**ADDENDUM NO. 3**

Date: August 21, 2023

**Project: Project #: 0146-465  
0146-465 Isador Cohen ES / Rosemont HS Security Improvements: Group 1**

SHEET NO. **C1.0.1**

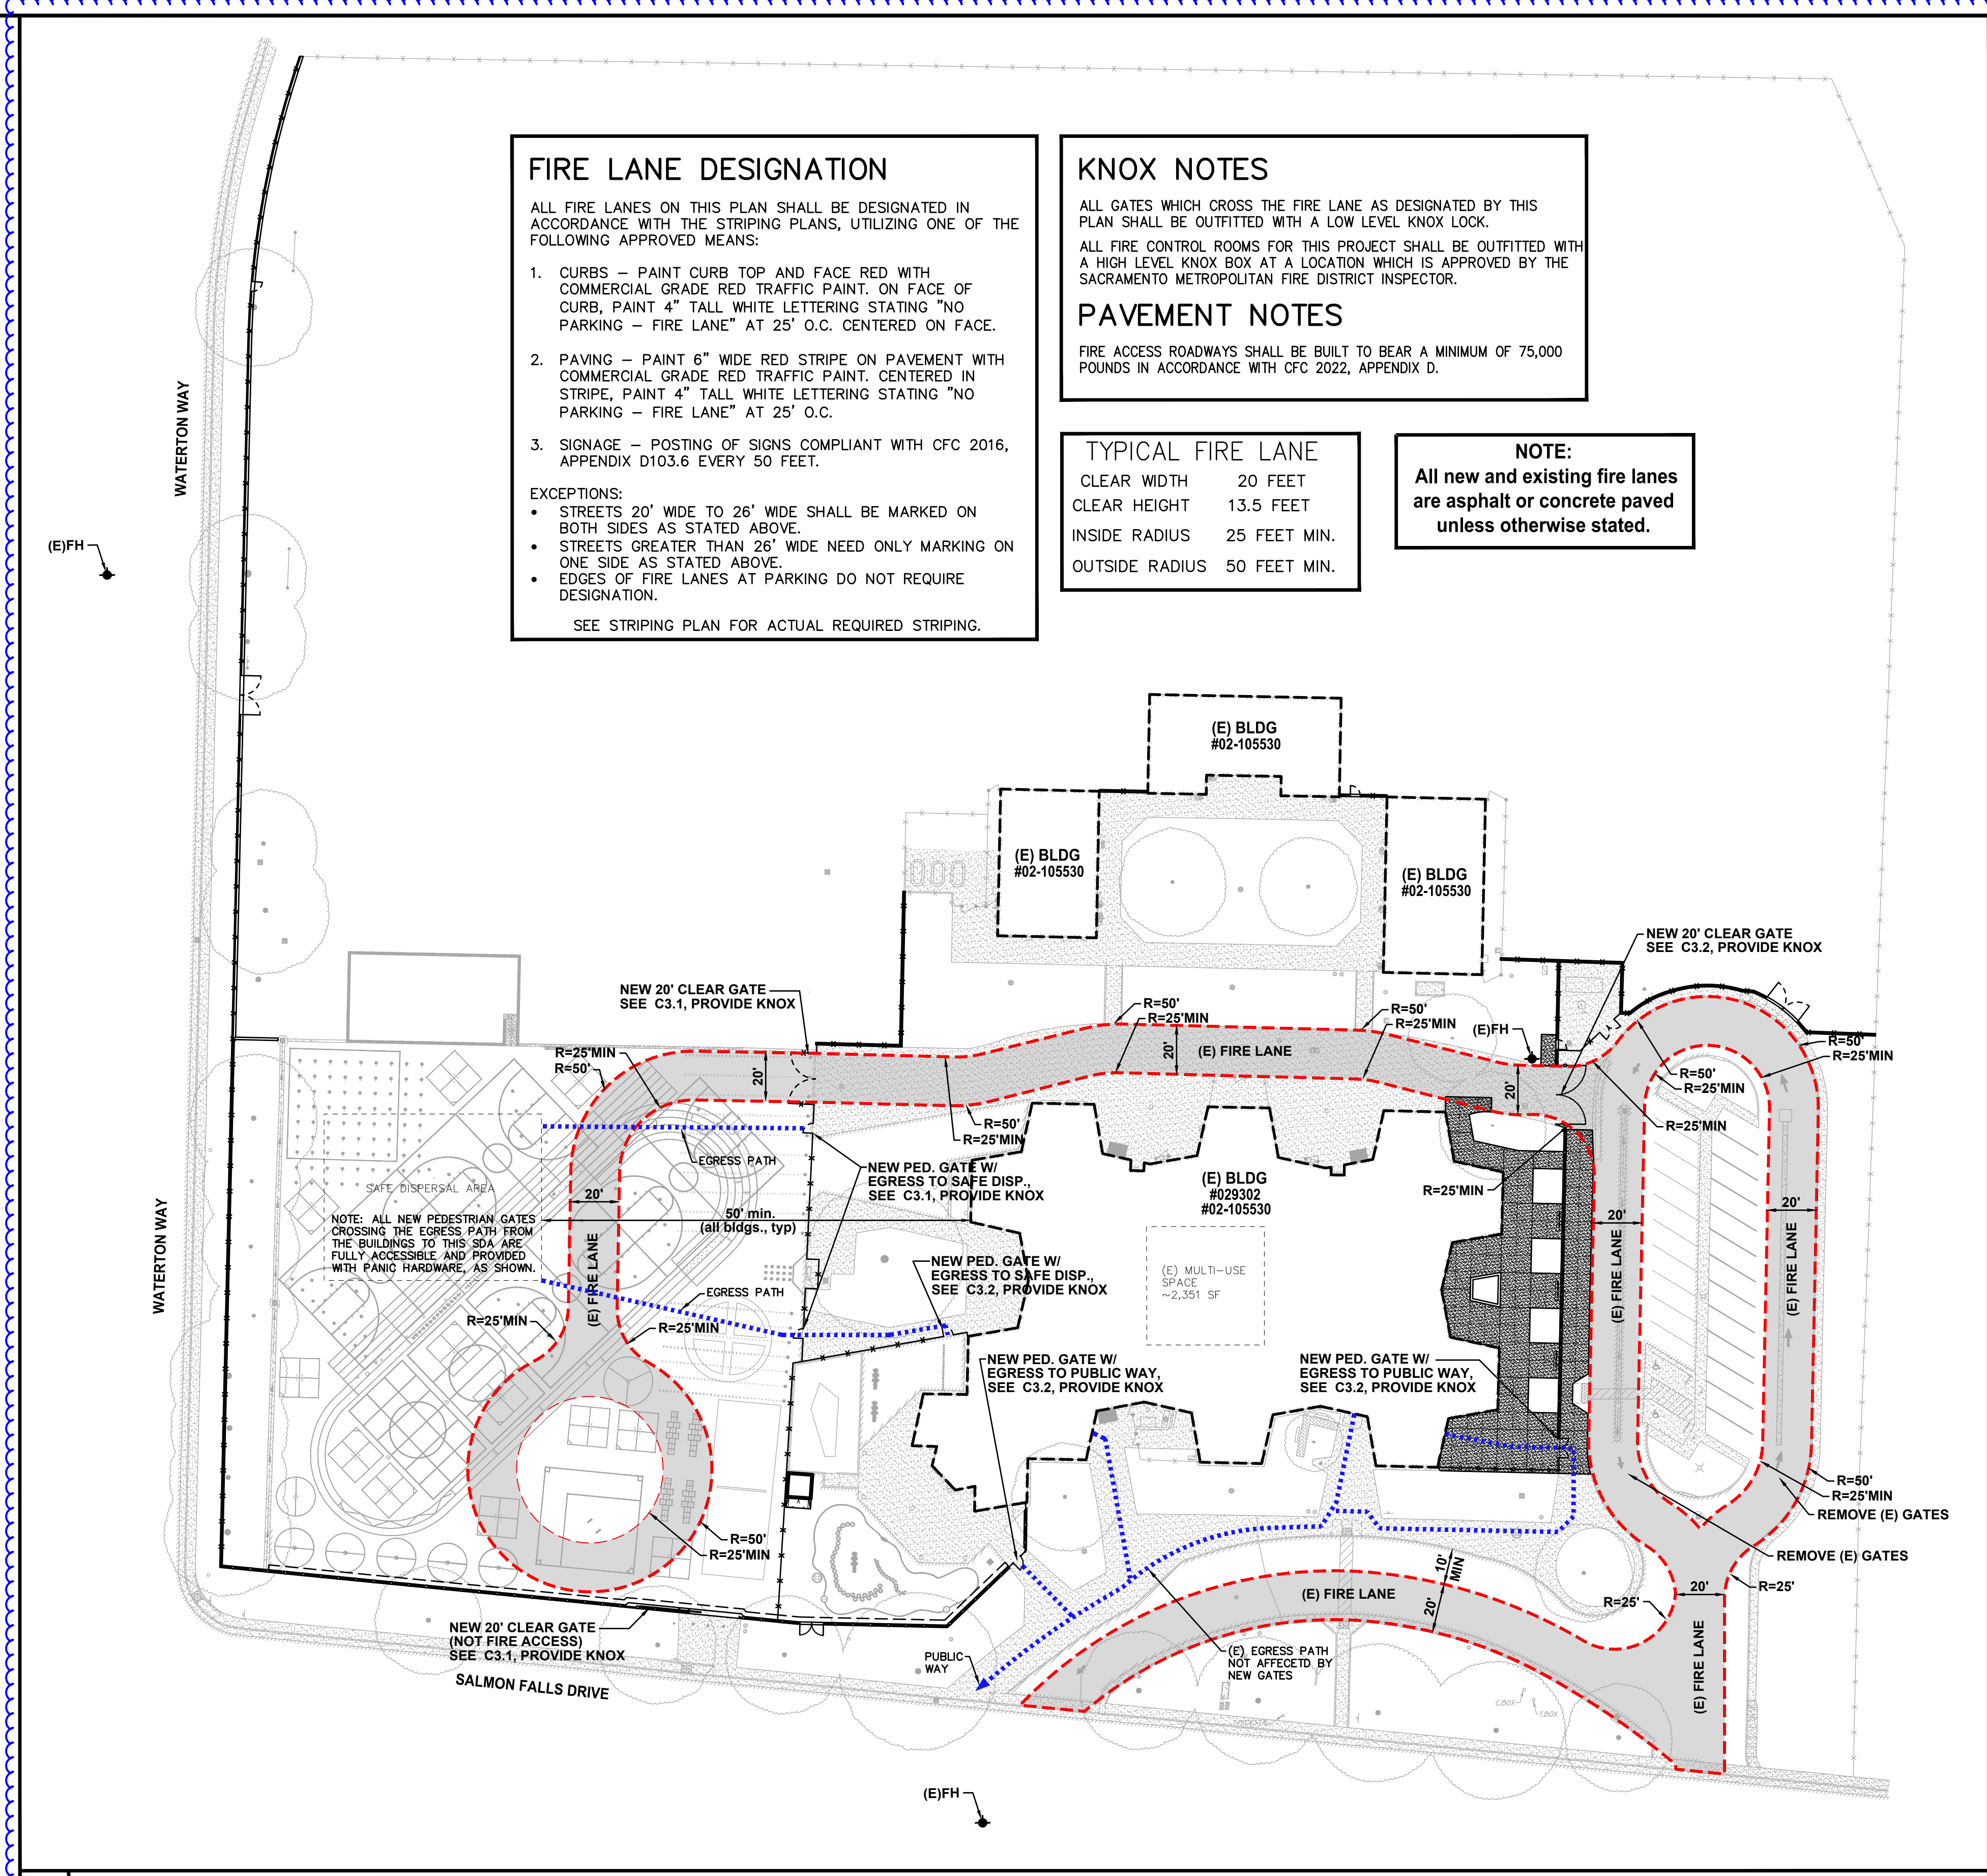
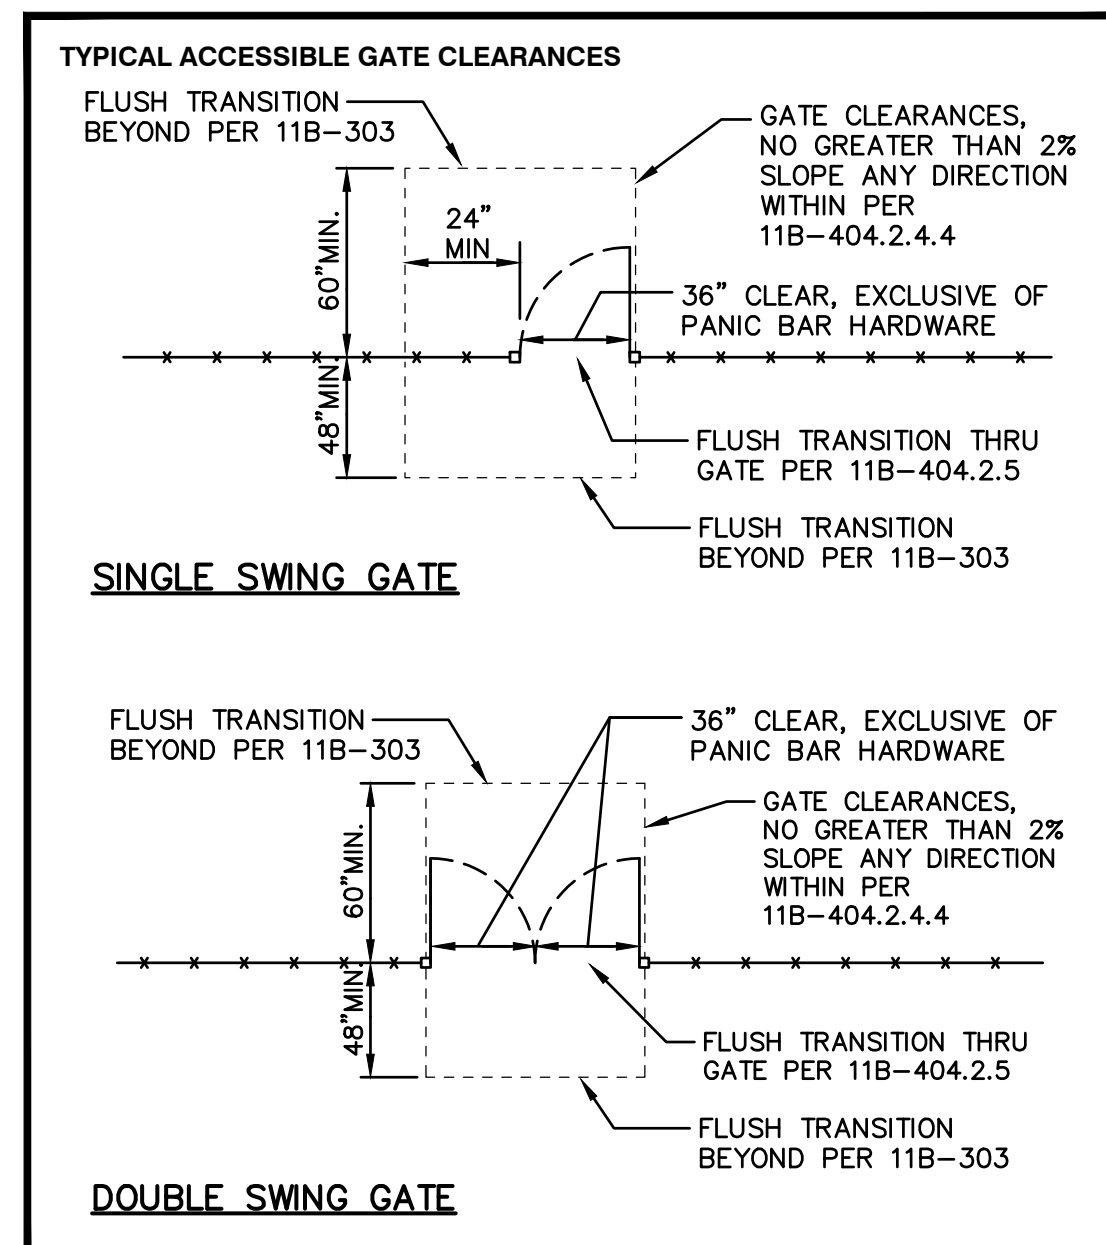
Sheet C1.0.1

- Site access plan updated with additional references.
- Gate legend added.
- General access notes added.
- Typical gate clearance details added.

SHEET NO.  
**C1.0.2**

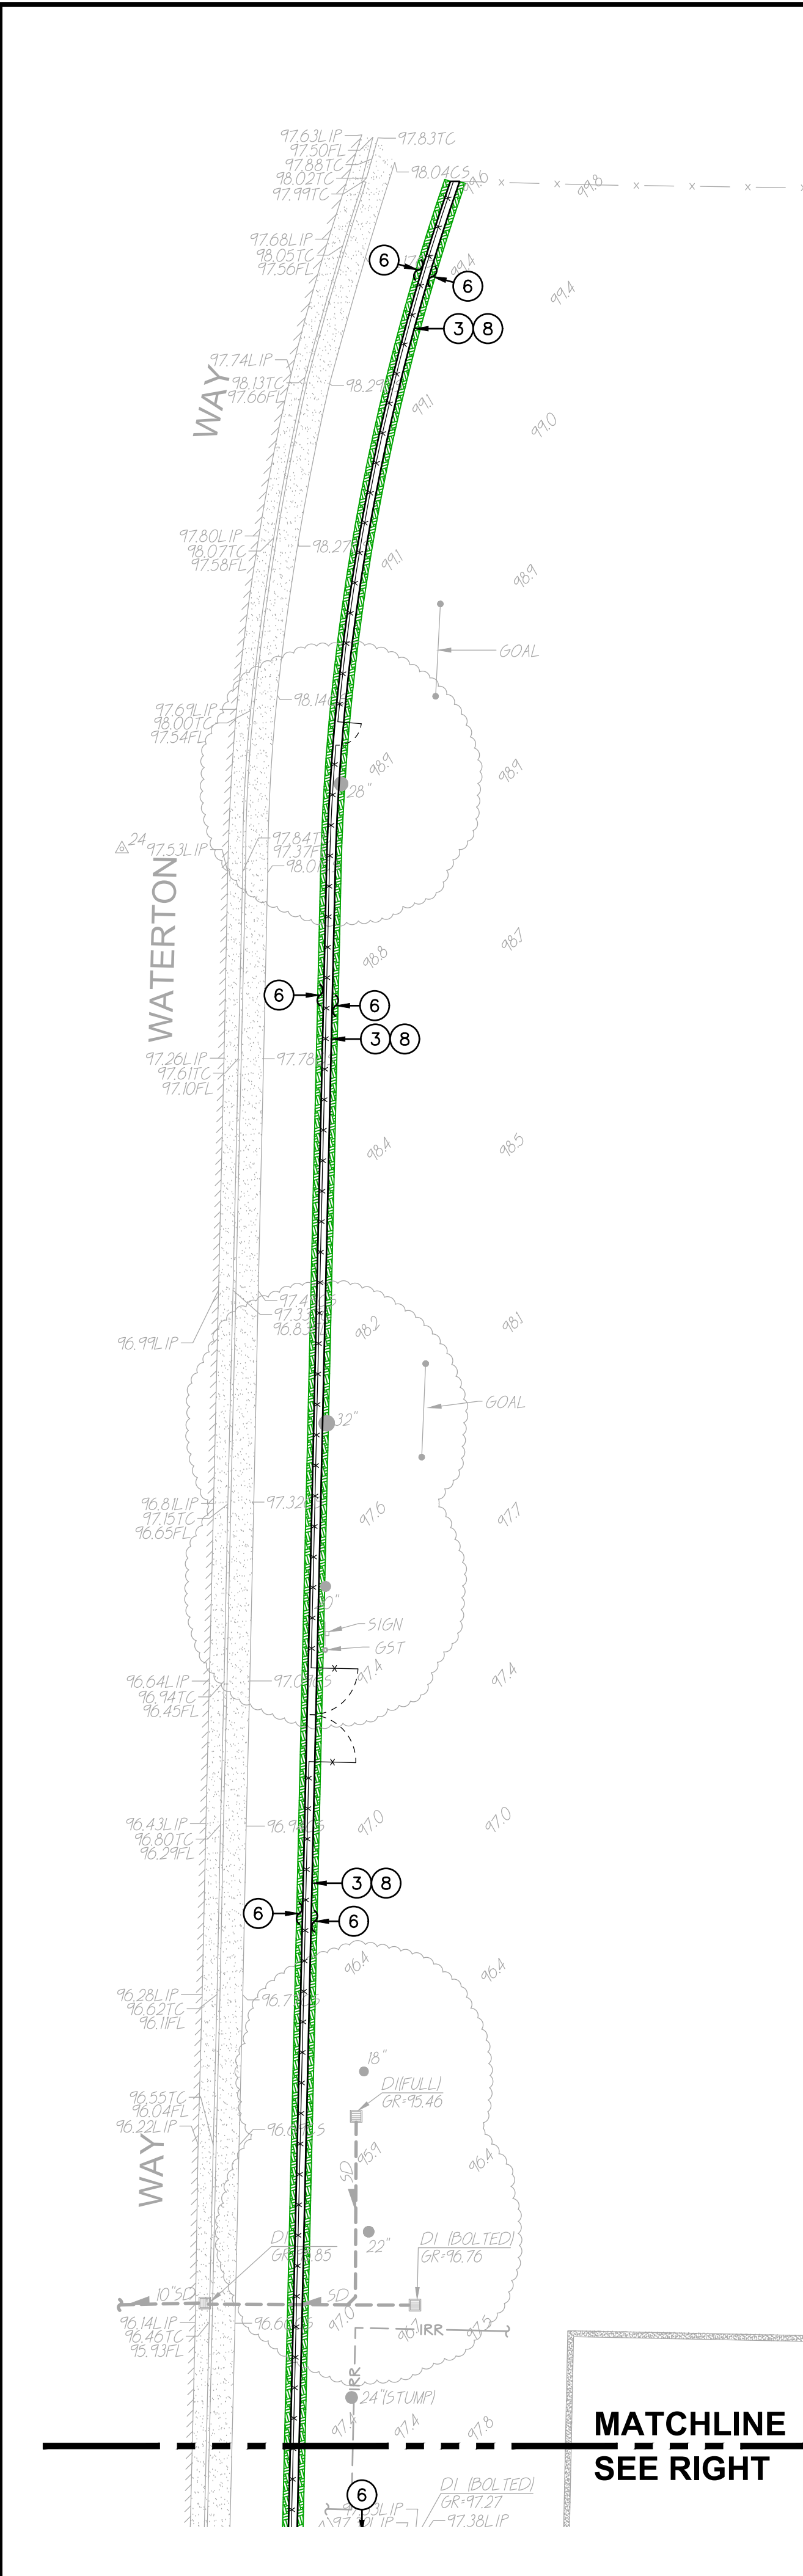
Sheet C1.0.2

- Site fire plan updated with additional references.
- Multi-purpose egress analysis provided.

SHEET TITLE:  
**GRADING PLAN**  
SHEET NO.  
**C2.1**

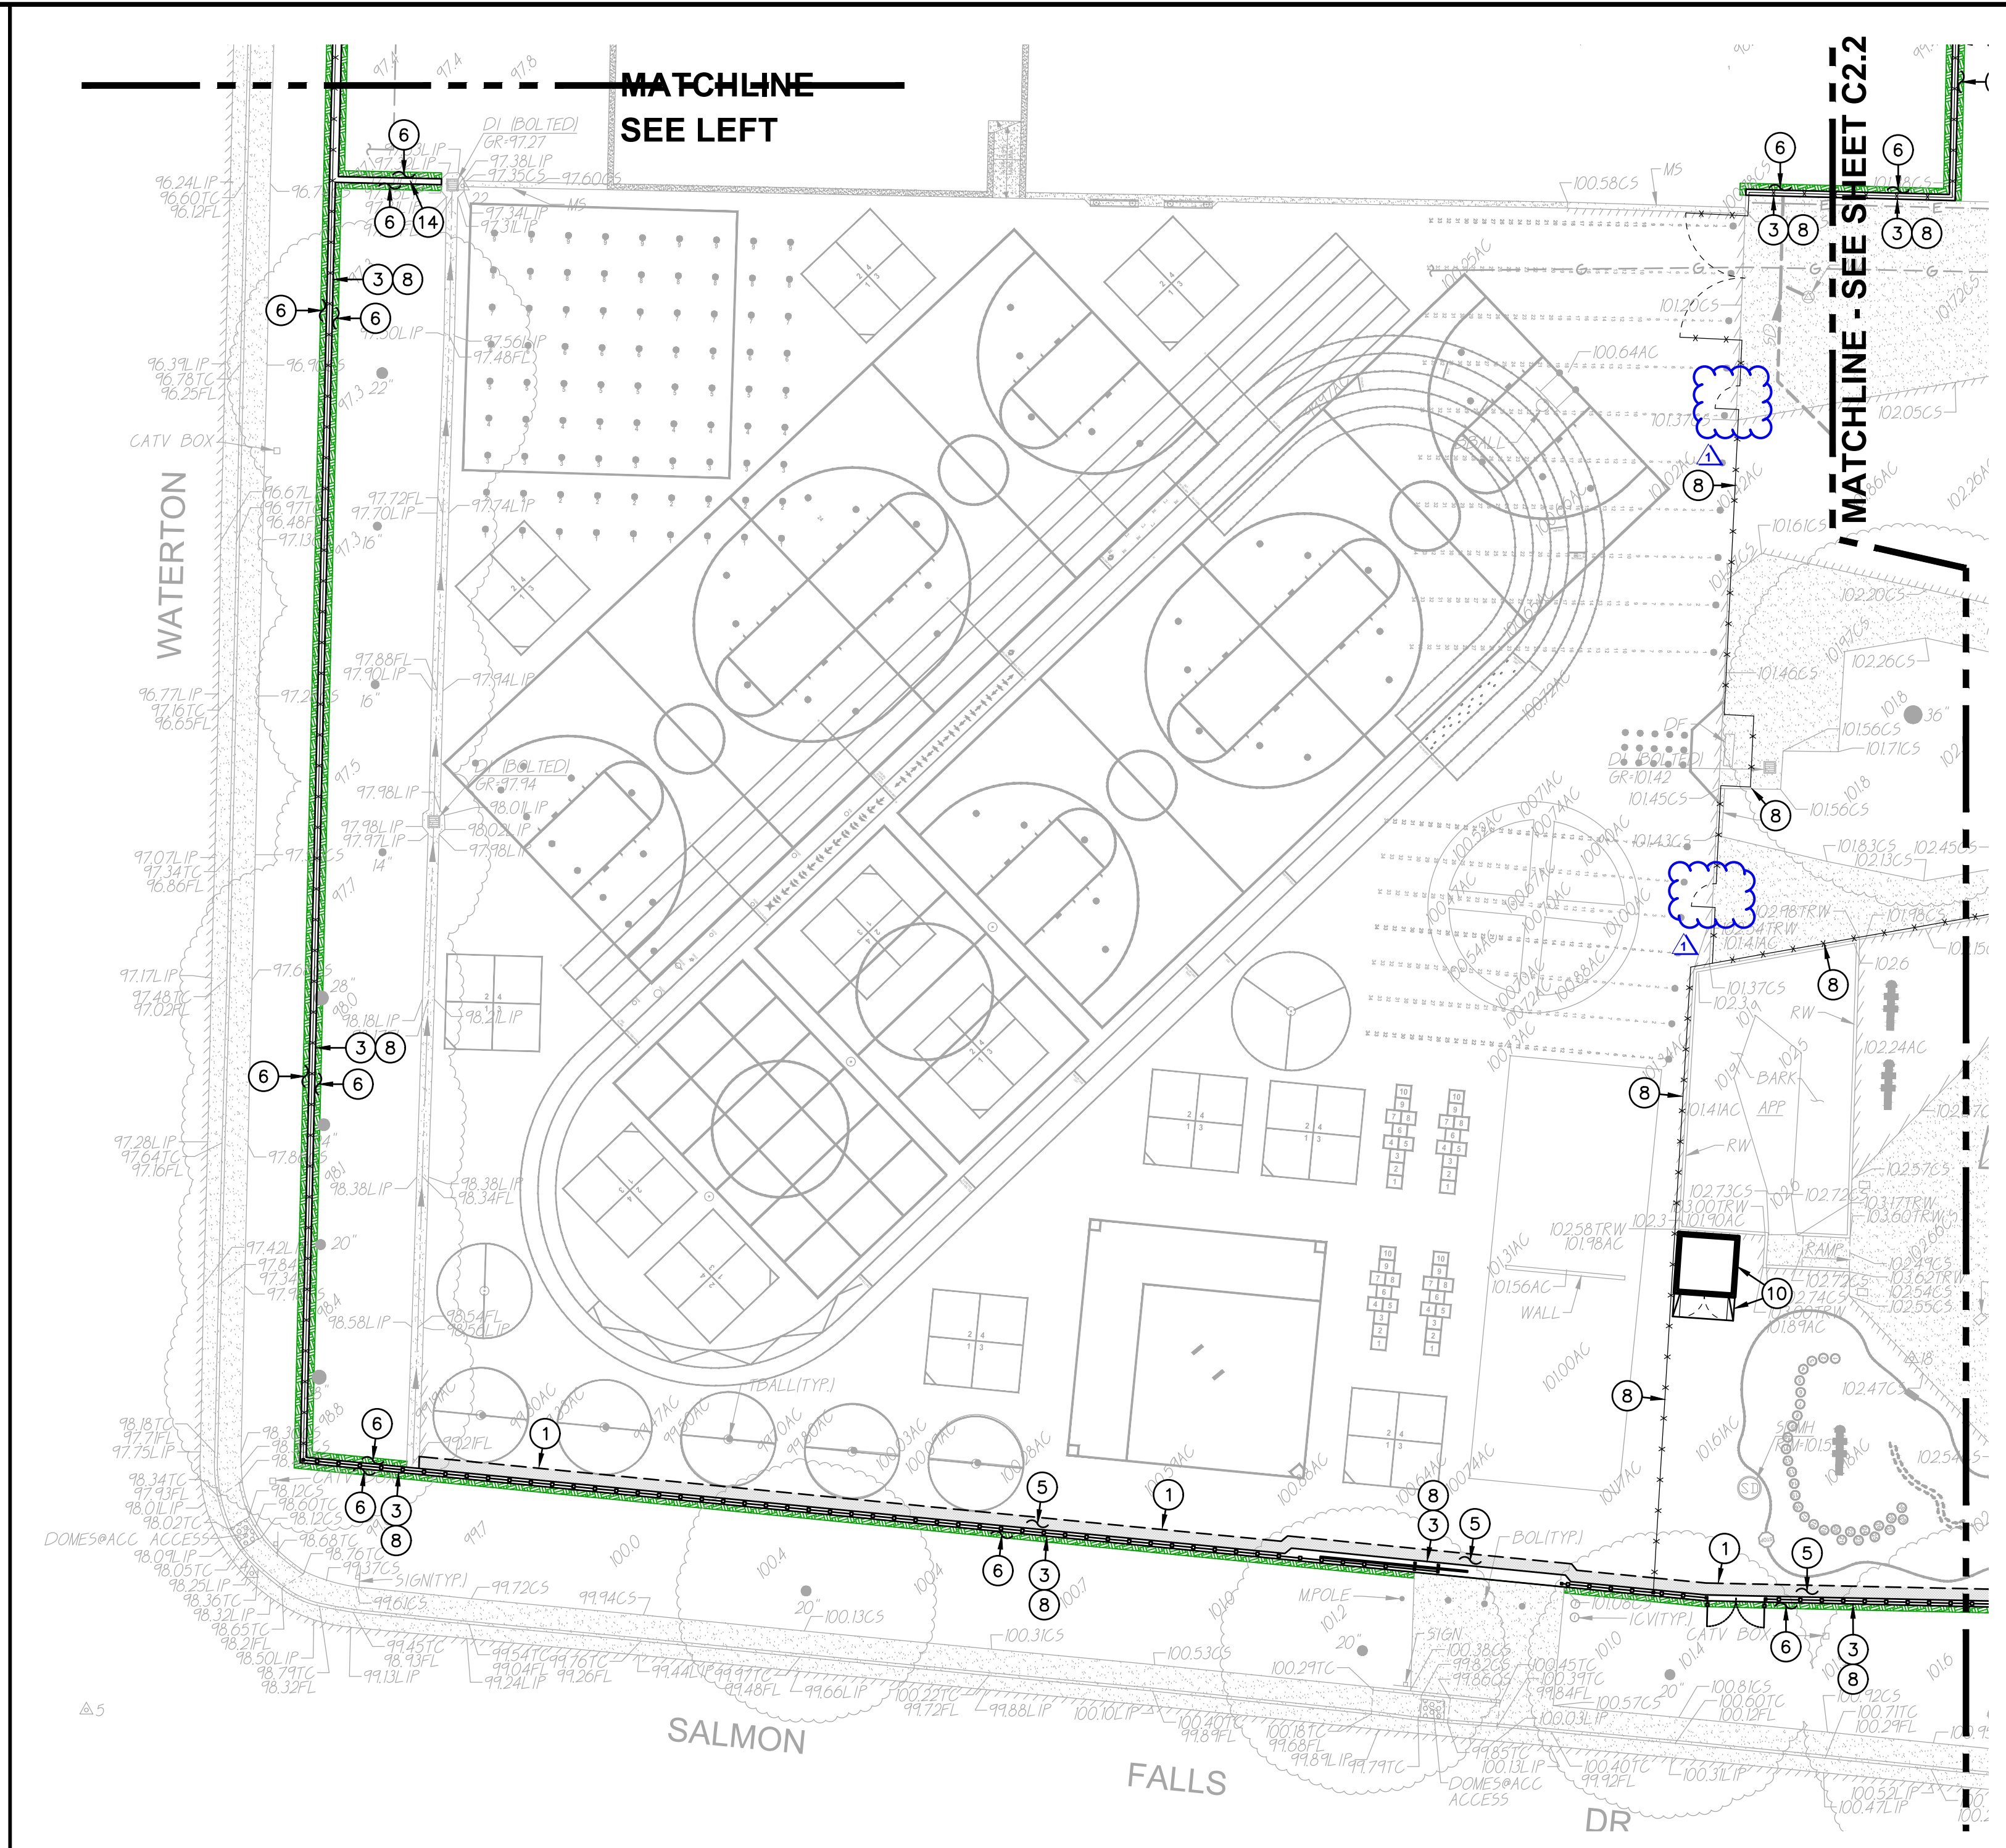
Sheet C2.1

- Surface repair general note added.
- Two new pedestrian gates added.
